# Access Compliance Report

## Public Rights-of-Way

### (Curb Ramps)

Intersection ID: 13197	Main Street: S_MCDOWELL_ST	Cross Street: E_4TH_ST	Location: E
ADA ID: D038F0578A1F	Ramp Type: Directional	Initial Pass/Fail: Pass	Overall Compliance: No
Severity Score: 5			
Codes/Mitigation Info/Possible Solution		Field Measurements/Component Compliance

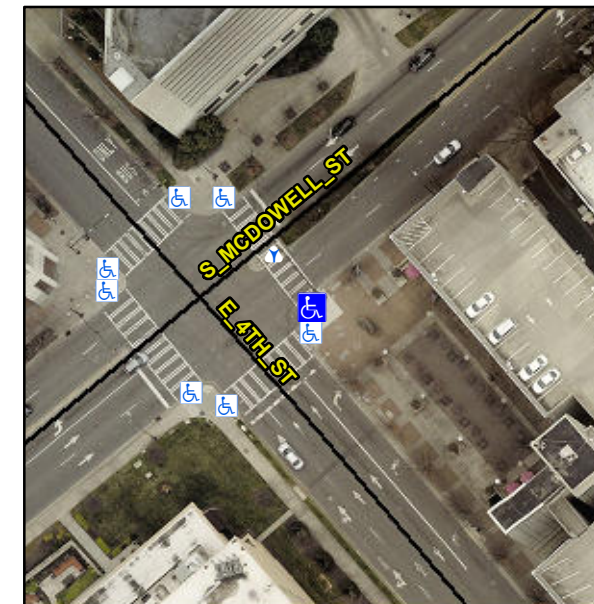
**Remove & Replace Curbed Edge.**

**R304.2.3**
